GENERAL NOTES (FOR ALL P&ID EDITS):

- A. DRAWING NUMBERS CHANGED
- B. CLOUDS DENOTE ADDITIONS/ MODIFICATIONS.
- C. NOTES USED FOR REMOVALS + ASSUMPTIONS.
- D. MAIN FLOWS, VALVE TYPES AND SIZES PRIORITISED.
- E. LINE NUMBERS STILL IN PROGRESS.
- F. INSTRUMENTS/ALARMS BASED ON MAINTENANCE LIST.
- G. HAND SWITCHES & FAULT ALARMS FOR ALL MOTORS.

ASPECT										TENNANT MINING					PROJECT: TENNANT MINING PTY LTD NOBLES NOB GOLD MINE				
THIS DRAWING IS THE PROPERTY OF ASPECT ENGINEERING SOLUTIONS PTY LTD AND IS PRIVATE, CONFIDENTIAL AND IS SUPPLIED ON THE EXPRESS UNDERSTANDING THAT IT IS NOT TO BE USED FOR ANY PURPOSE OR COMMUNICATED TO ANY OTHER PERSON WITHOUT THE WRITTEN PERMISSION OF THE PROPRIETORS.										TITLE: REAGENTS PIPING AND INSTRUMENTATION DIAGRAM					SHEET A1 SCALE NTS DRG No. NNGM-100-PI-005 REVISION 0				
REV										DATE					DESCRIPTION				
DRAW										CHECK					DESIGN				
TECH APP										PROJ APP					REFERENCES				
DRG No.

PROJECT: TENNANT MINING PTY LTD NOBLES NOB GOLD MINE			
TITLE: PROCESS WATER AND AIR SERVICES PIPING AND INSTRUMENTATION DIAGRAM			
SHEET A1	SCALE NTS	DRG No. NNGM-100-PI-012	REVISION 0

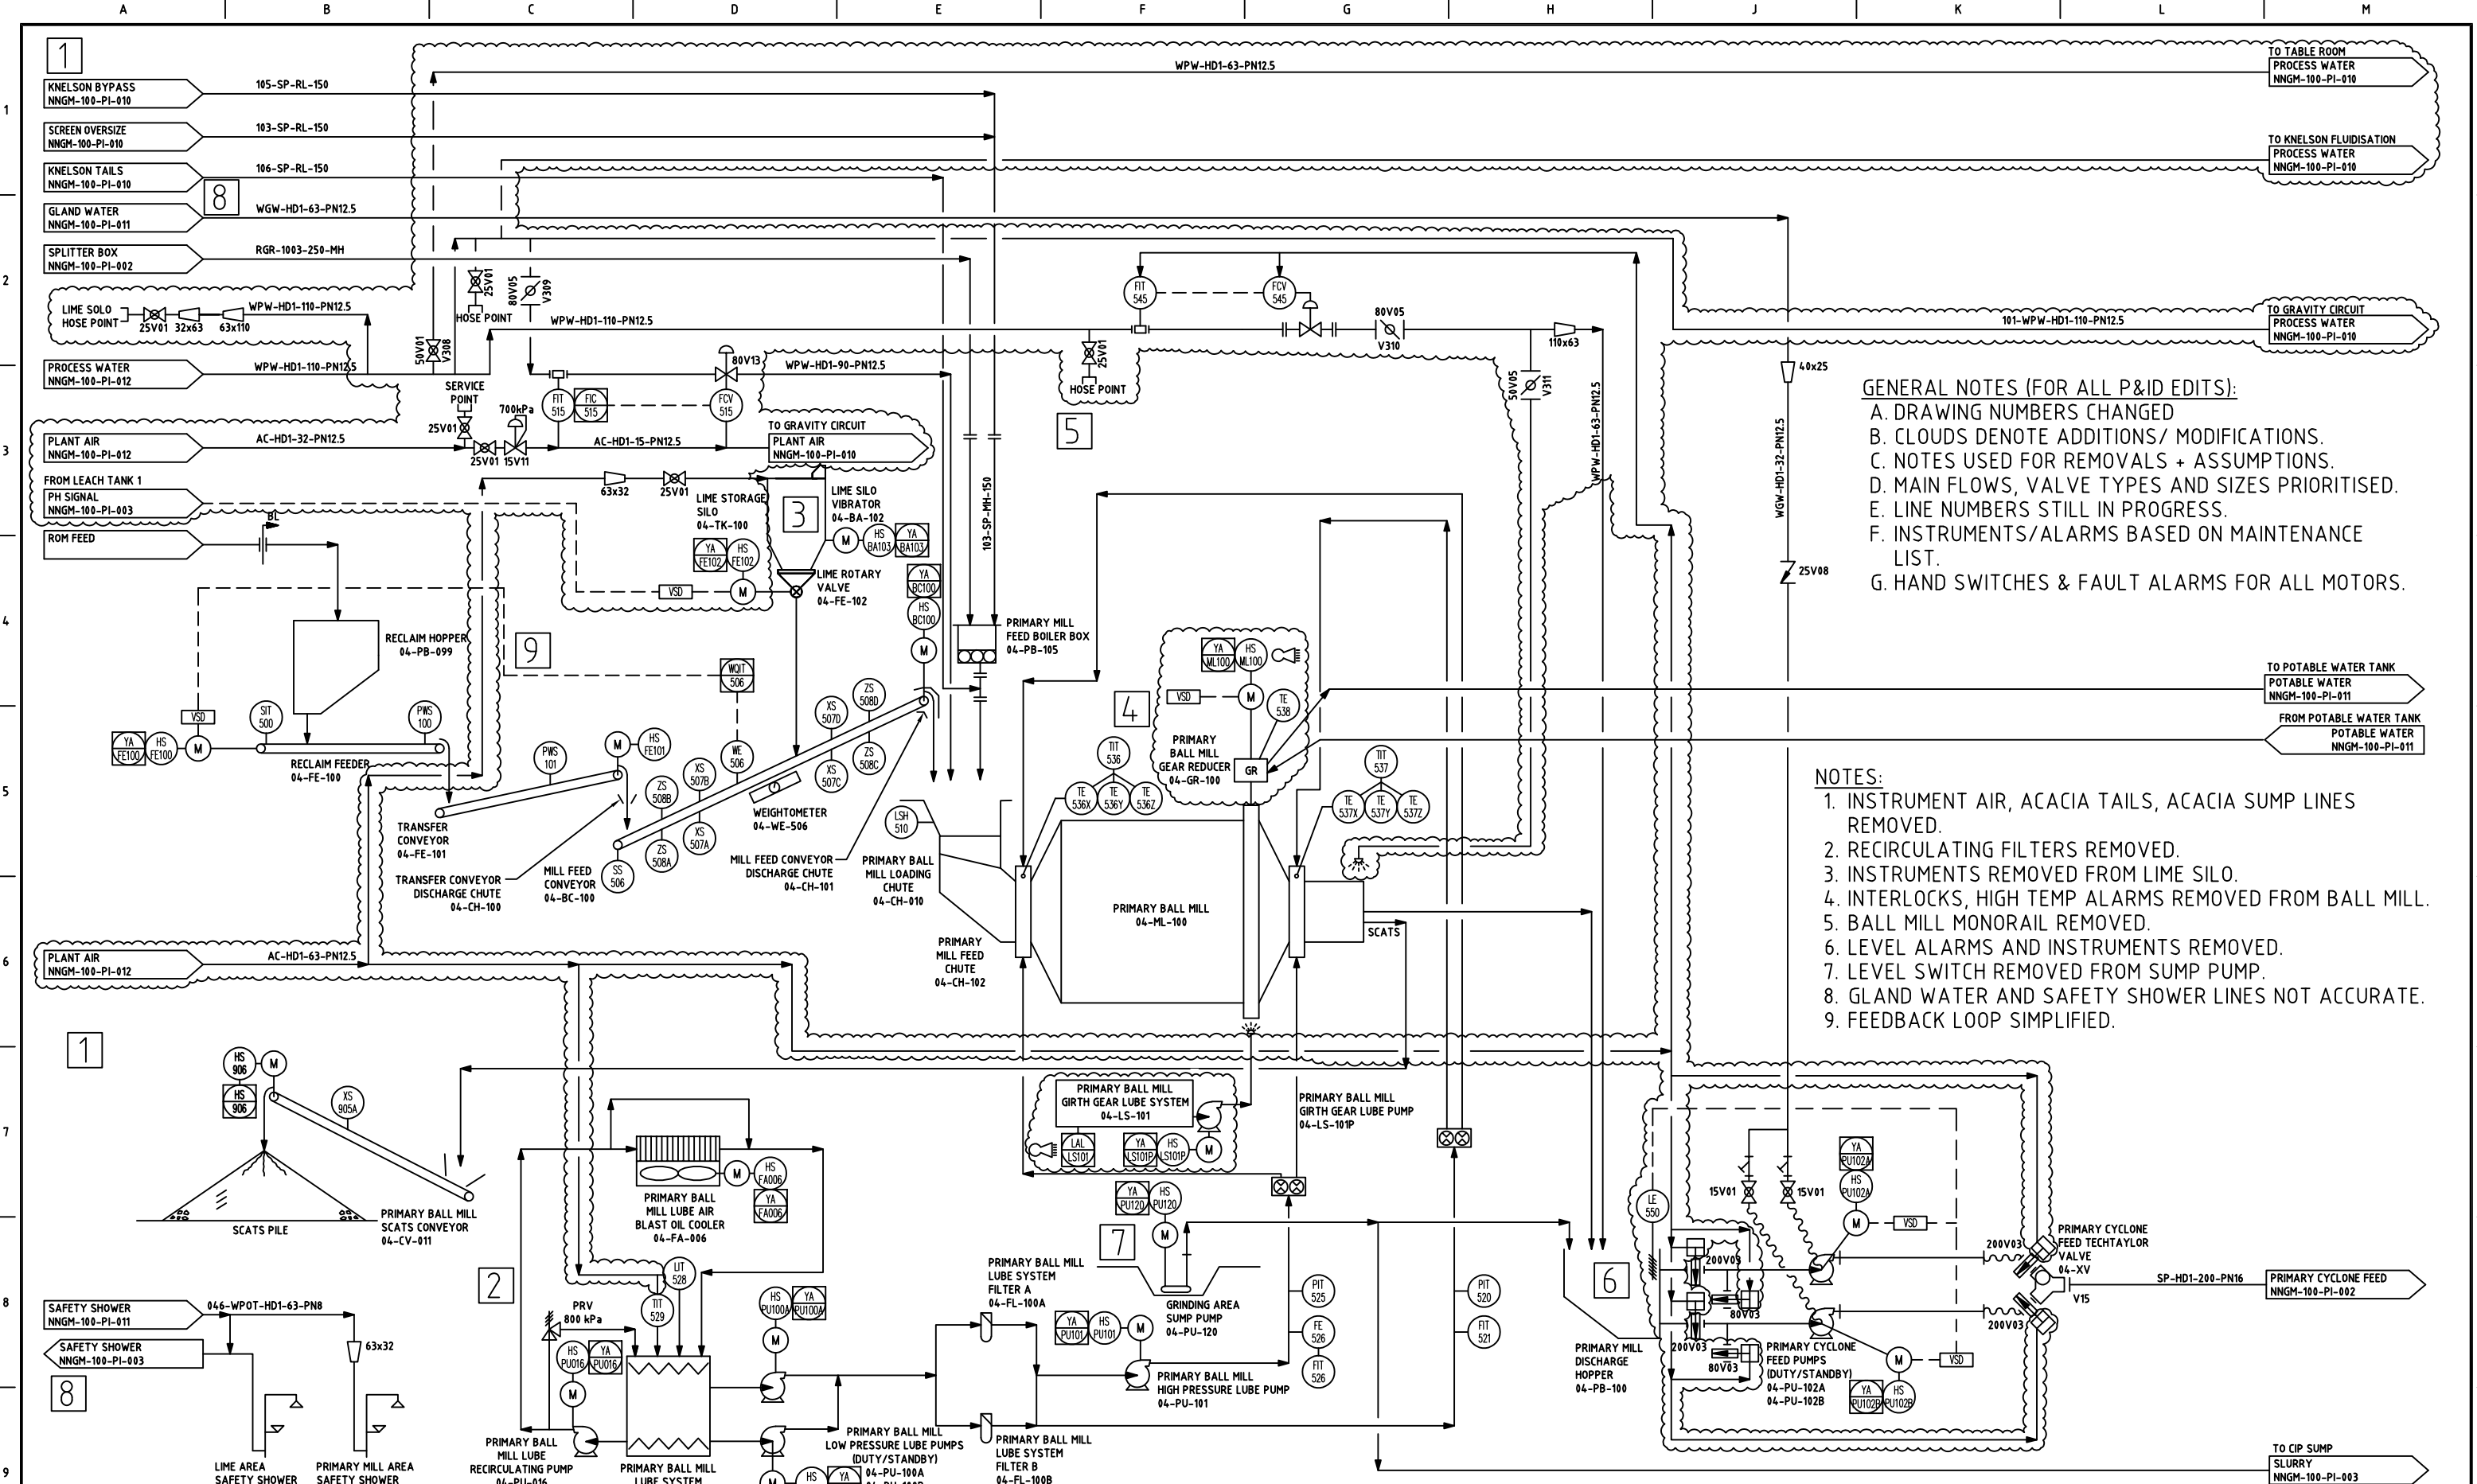
- NOTES:
- 1. INSTRUMENT AIR, ACACIA TAILS, ACACIA SUMP LINES REMOVED.
 - 2. RECIRCULATING FILTERS REMOVED.
 - 3. INSTRUMENTS REMOVED FROM LIME SILO.
 - 4. INTERLOCKS, HIGH TEMP ALARMS REMOVED FROM BALL MILL.
 - 5. BALL MILL MONORAIL REMOVED.
 - 6. LEVEL ALARMS AND INSTRUMENTS REMOVED.
 - 7. LEVEL SWITCH REMOVED FROM SUMP PUMP.
 - 8. GLAND WATER AND SAFETY SHOWER LINES NOT ACCURATE.
 - 9. FEEDBACK LOOP SIMPLIFIED.

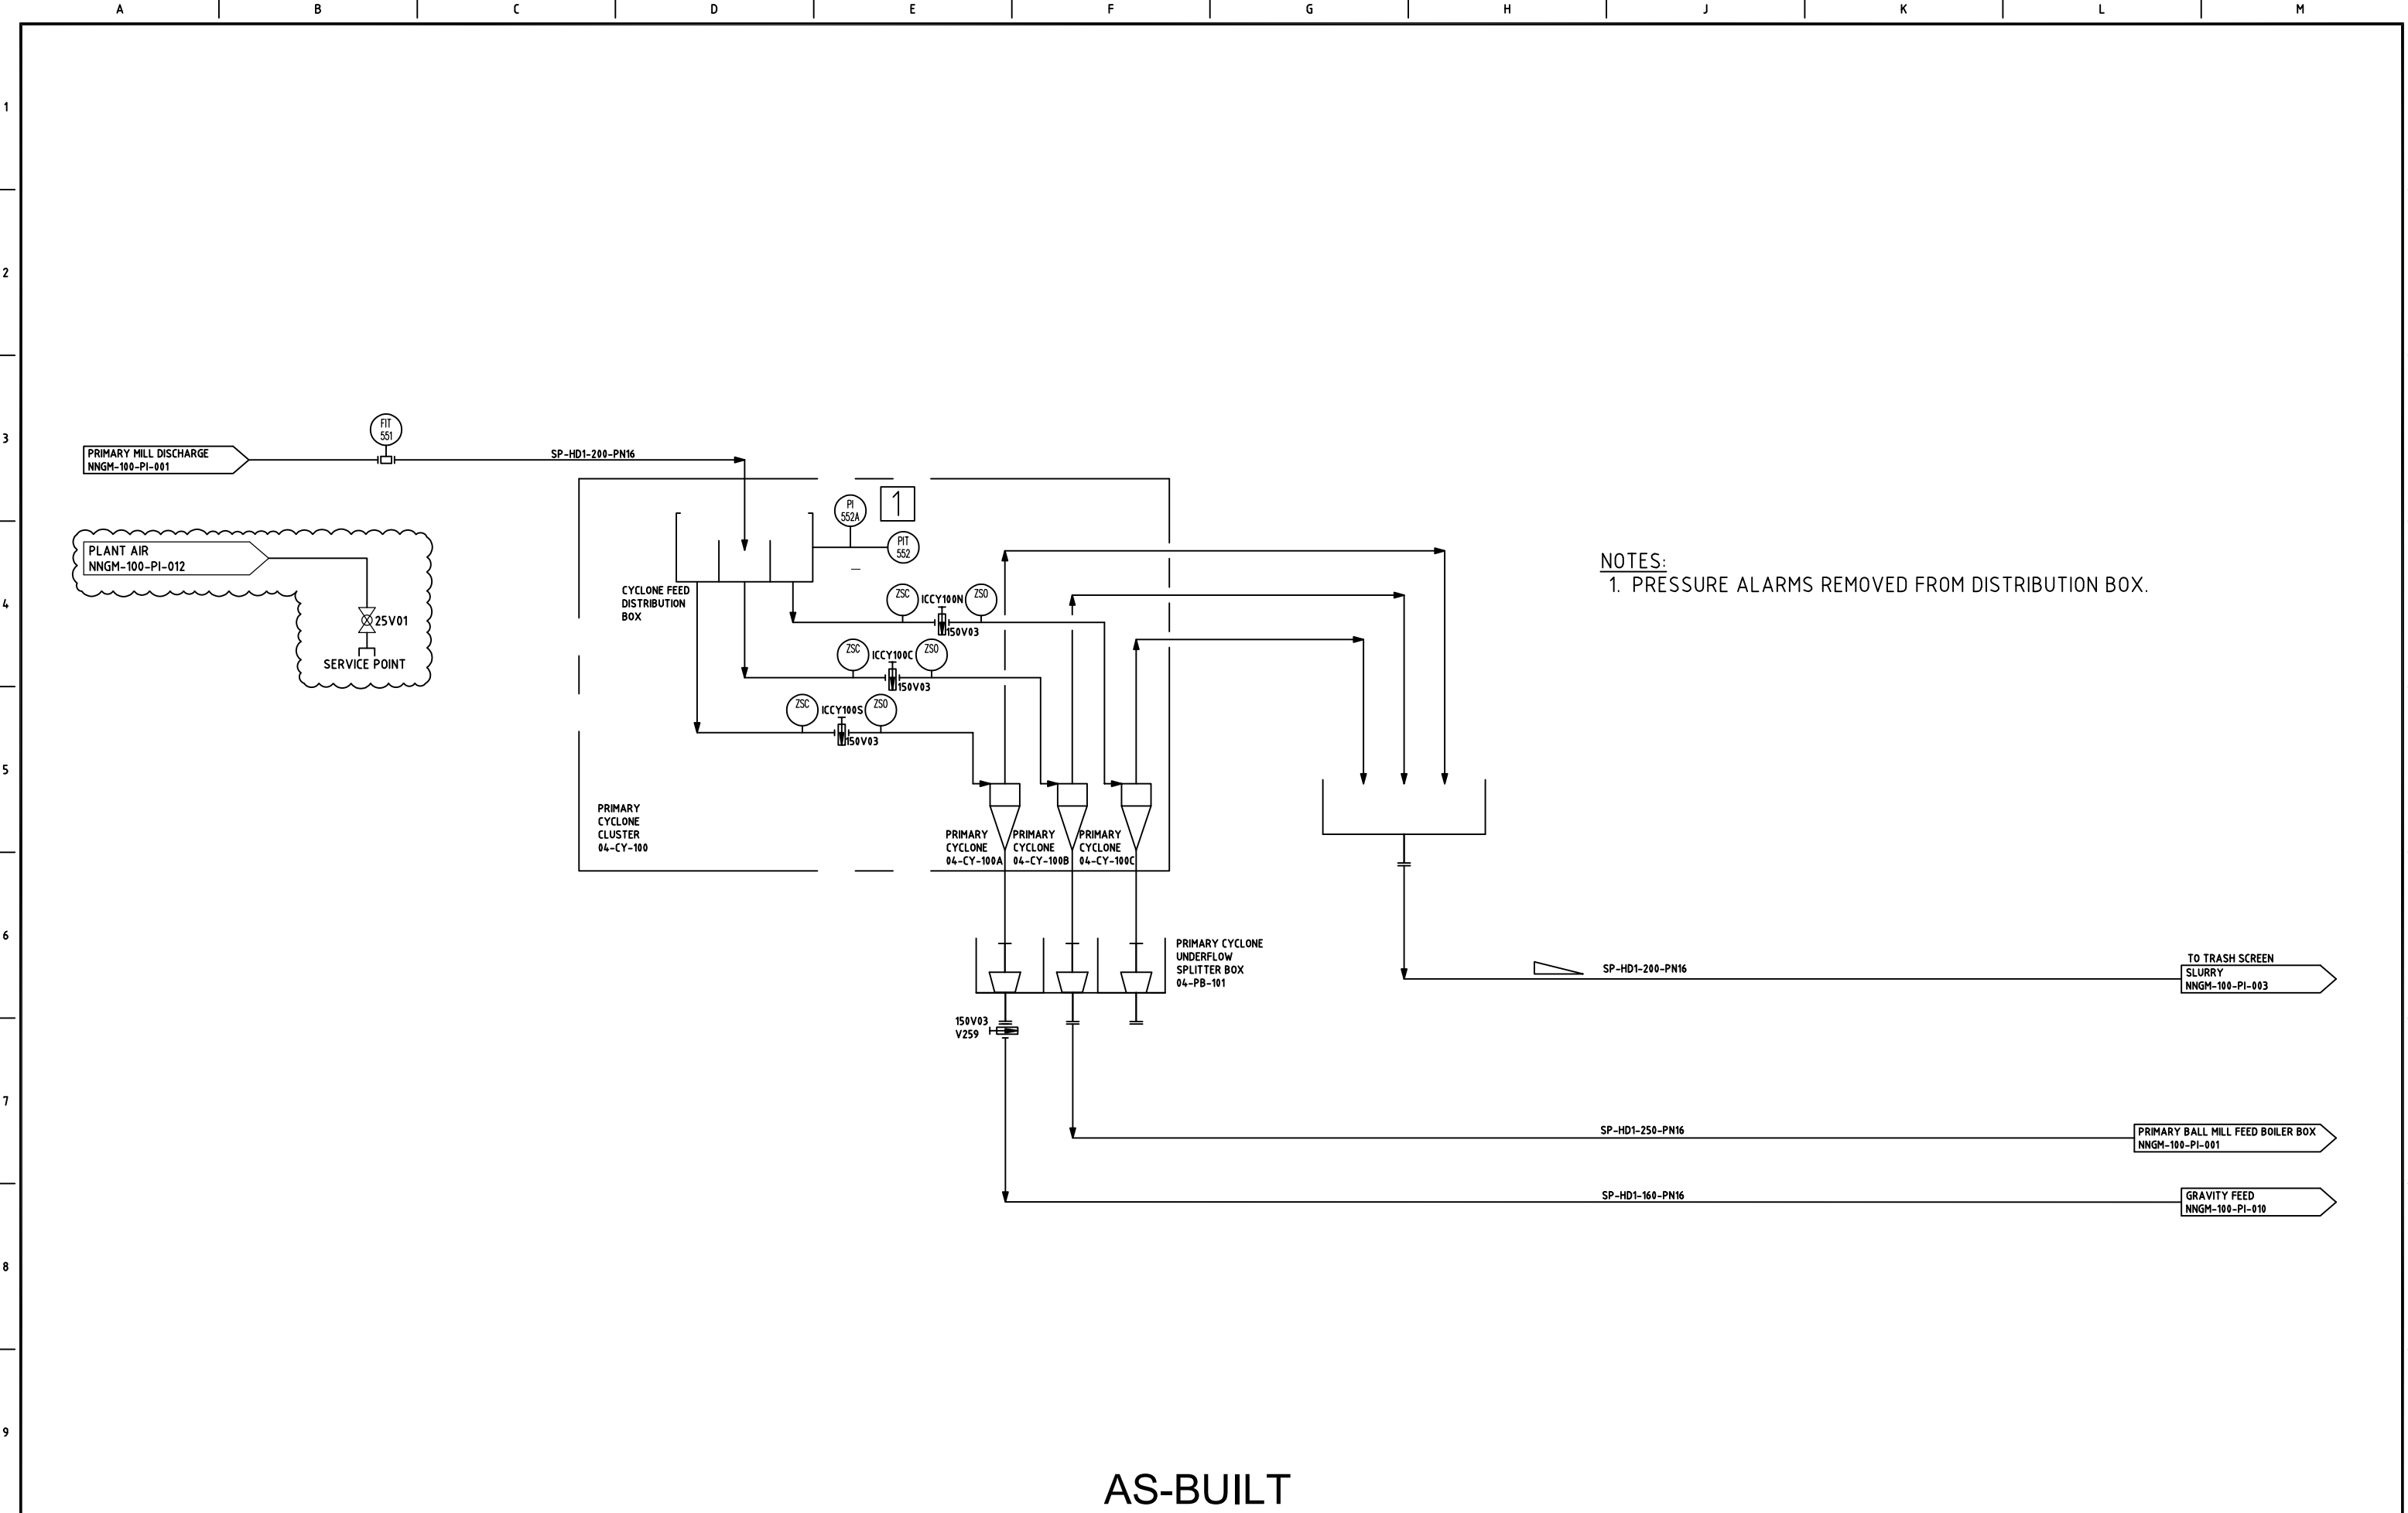
NOTES:
1. PRESSURE ALARMS REMOVED FROM DISTRIBUTION BOX.
